ADDENDUM #5

DATE: 7/09/2025
SUBJECT: ASMSA FB-25-006
Maintenance Building & Wood Shop
111C Cedar Street
Hot Springs, Arkansas
Project No.: 24-69

Item No. 1 Drawings, Sheets C.4 – Civil Utility Plan and A1.1 – Architectural Floor Plan

ASMSA - MAINT. BUILDING & WOOD SHOP
PARTIAL OF SHT C.4
N.T.S.
APPENDUM #5, ITEM #5

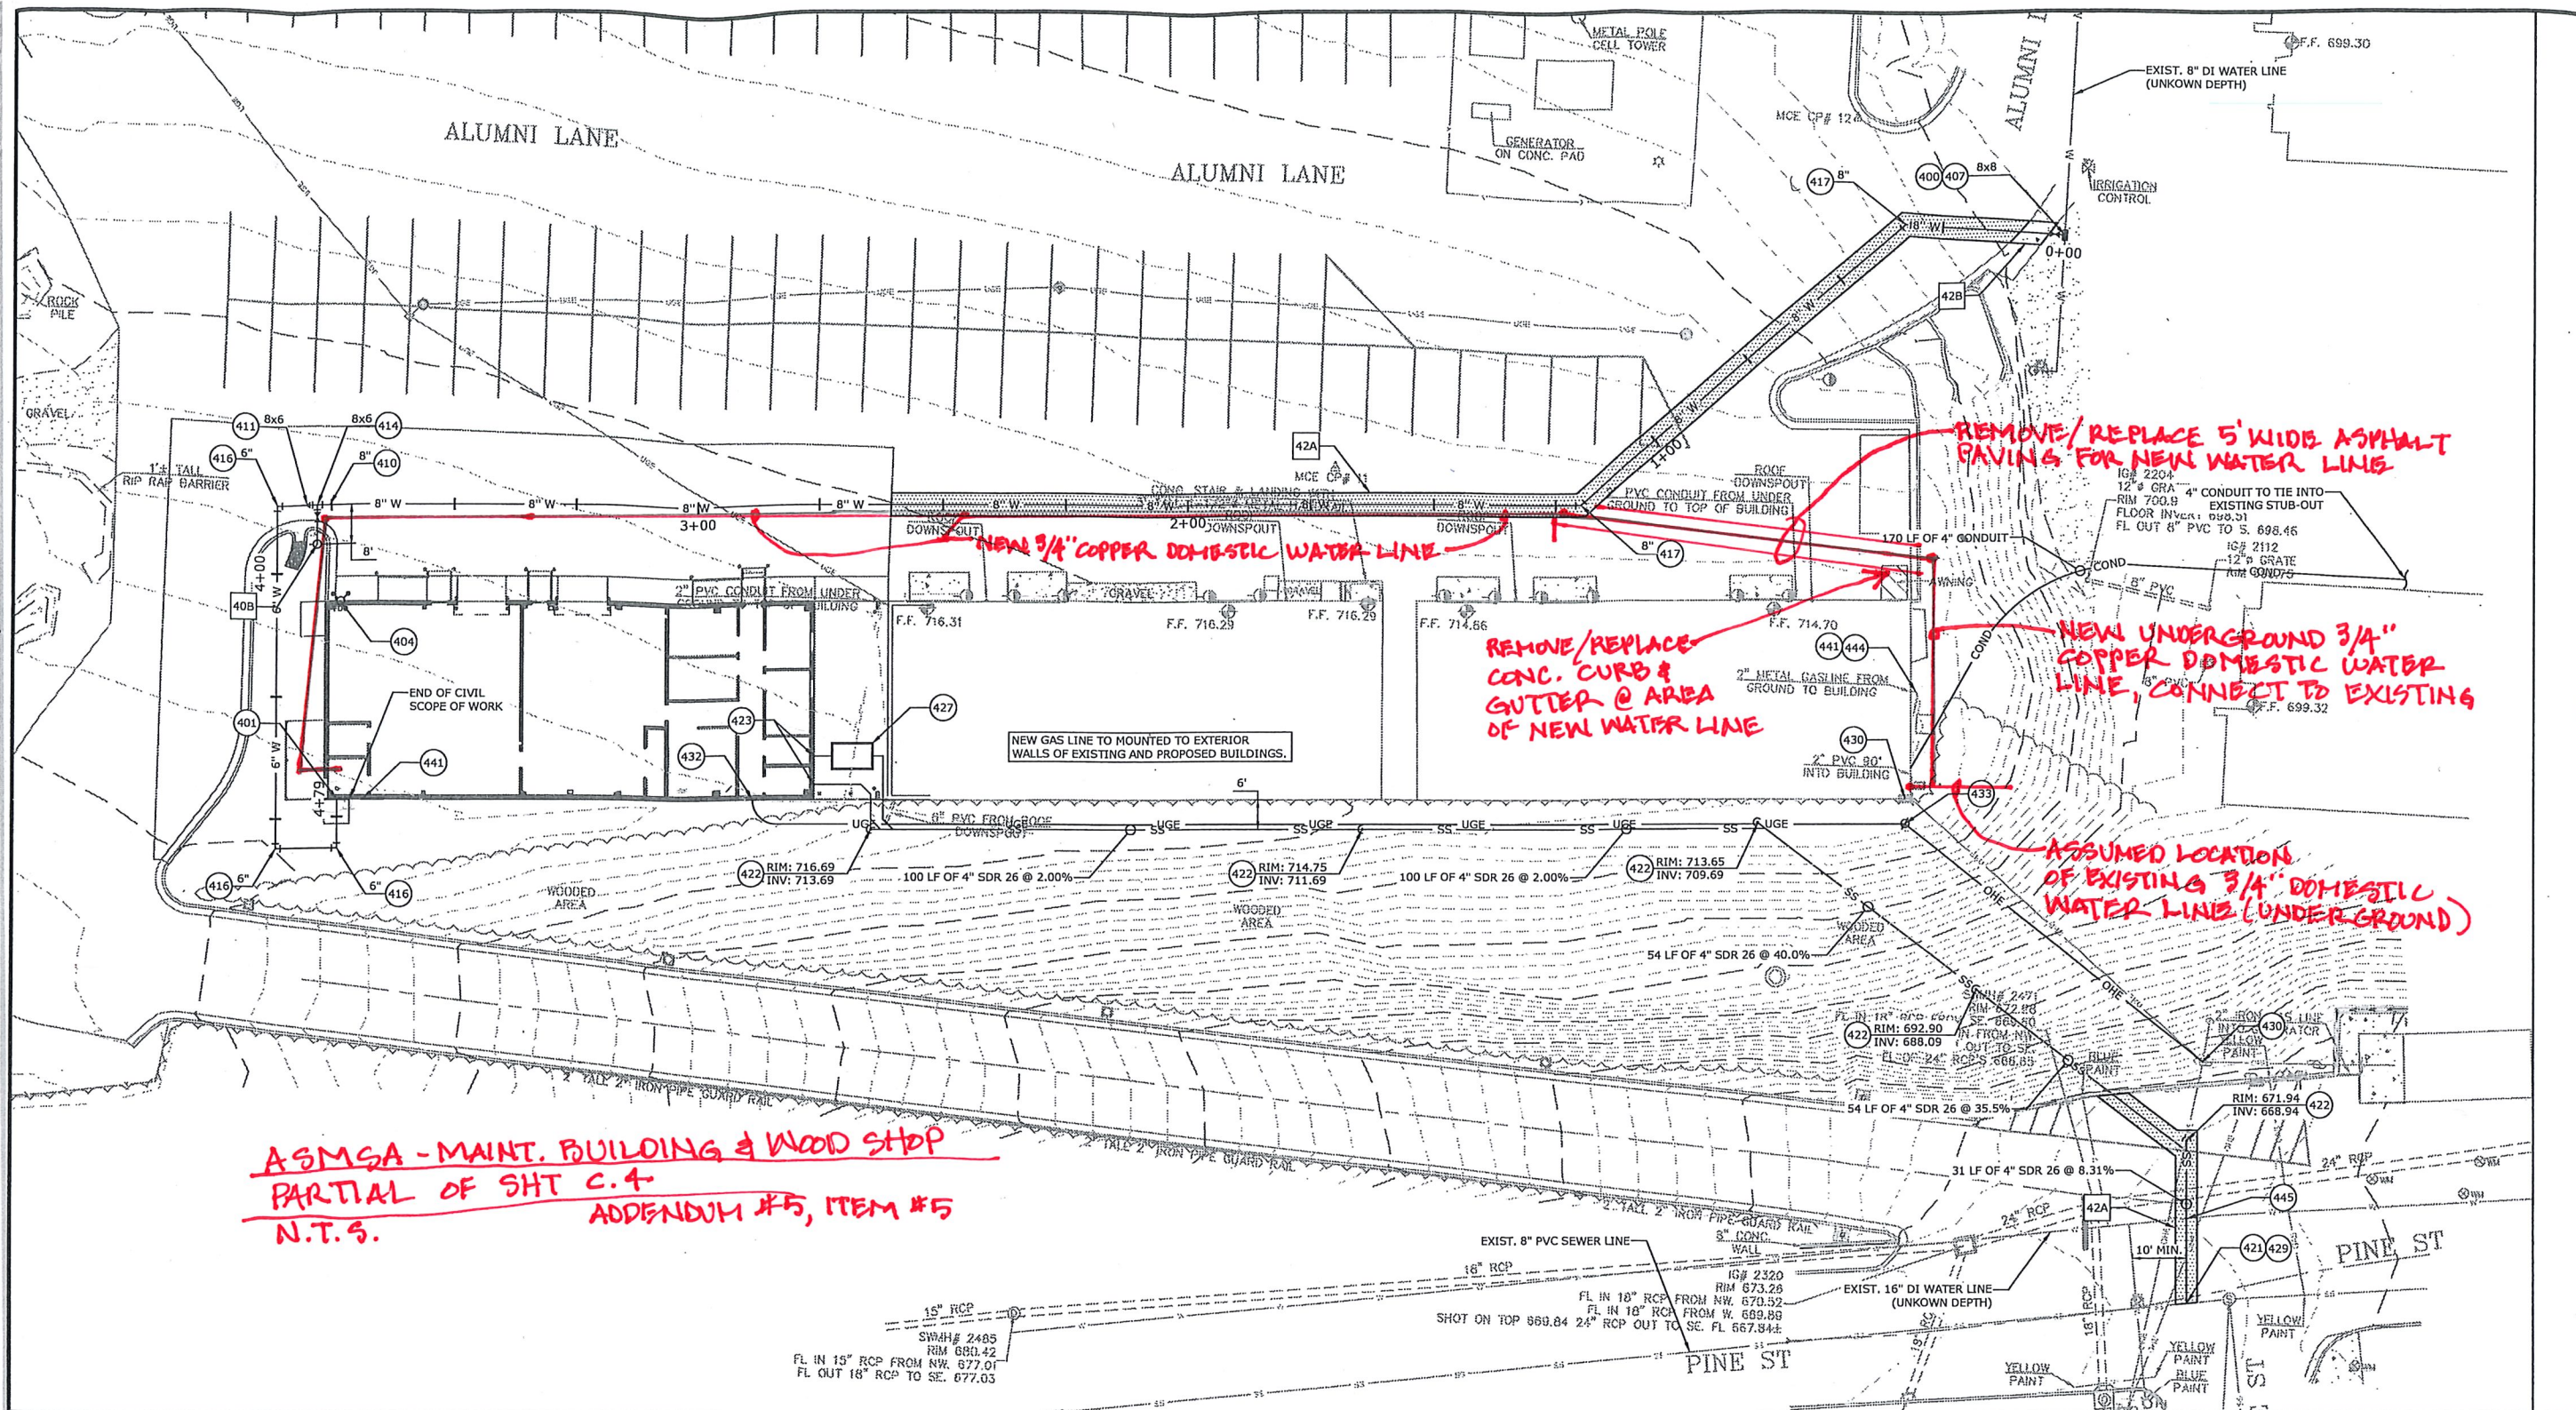
A. C.4 and A1.1: The note “ 4” conduit to tie into existing stub-out” shall be changed to read: “furnish and install new 4” underground conduit to East side of existing building, conduit shall then extend 18” up wall to a new weatherproof 8x8 junction box, a 4” conduit shall extend 18” out of the back of the box thru the existing wall and into the existing Data/IT room. Paint all exposed conduit and the J-box. All wall materials shall be repaired to match existing conditions/ construction. The Owner shall install a new fiber optic line within this new conduit.”

B. C.4: The scale is 1” = 20’, not 1” = 10’.
